V2500-A5/D5 SERIES PROPULSION SYSTEMS SERVICE BULLETIN

ENGINE – ACTUATING MECHANISM HP COMPRESSOR VARIABLE VANES – INTRODUCTION OF A STAGE 4
AND 5 CONNECTOR BRACKET LOCATION DOWELS WITH REDUCED LENGTH – REWORK

V2500-ENG-72-0444

Rework of Dowel
Figure 1

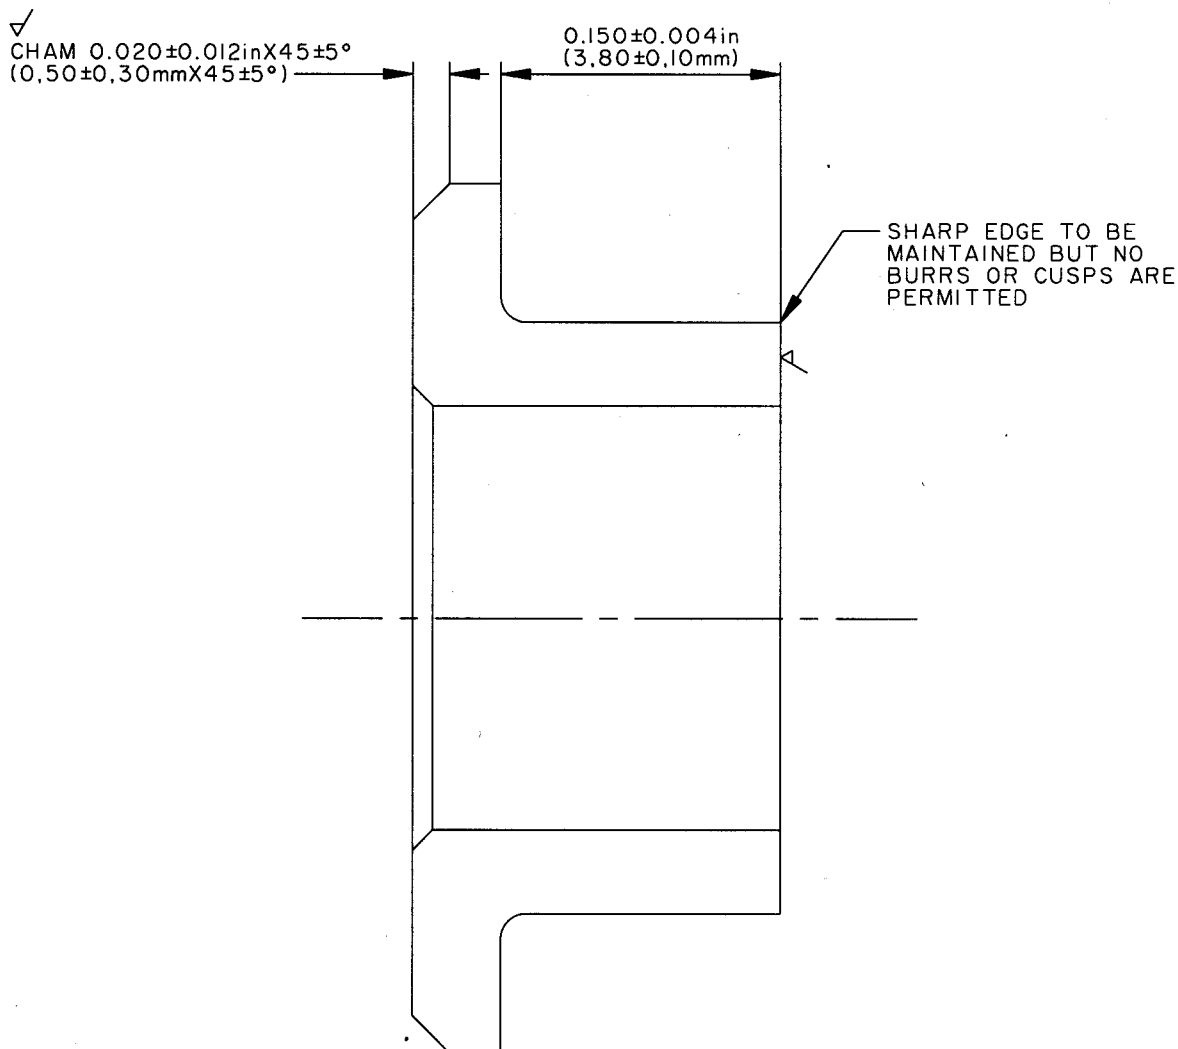
Cracking of the Stage 4 and 5 VSV control rod brackets may occur. The problem has been attributed to the shank length of the locating dowel being too long. This causes fretting between the actuator bracket and the dowel, which in turn leads to fretting between the bracket and unison ring which results in high cycle fatigue.

- (a) A revised dowel is introduced, similar to the existing item except for a reduction in the maximum dowel shank length such that a minimum clearance of 0,1 mm. is maintained between the bottom of the dowel and the unison ring boss.

- (2) Existing Location Dowels may be reworked. See Figure 1.

Refer to Figure 1 for new machining dimensions of the Location Dowel.

MACHINE WHERE SHOWN \checkmark
MACHINED SURFACE FINISH TO BE 125 MICROINCHES (3.2 MICROMETRES)
REMOVE THE SHARP EDGES $0.012 \pm 0.008 \text{ in}$ ($0.30 \pm 0.20 \text{ mm}$).
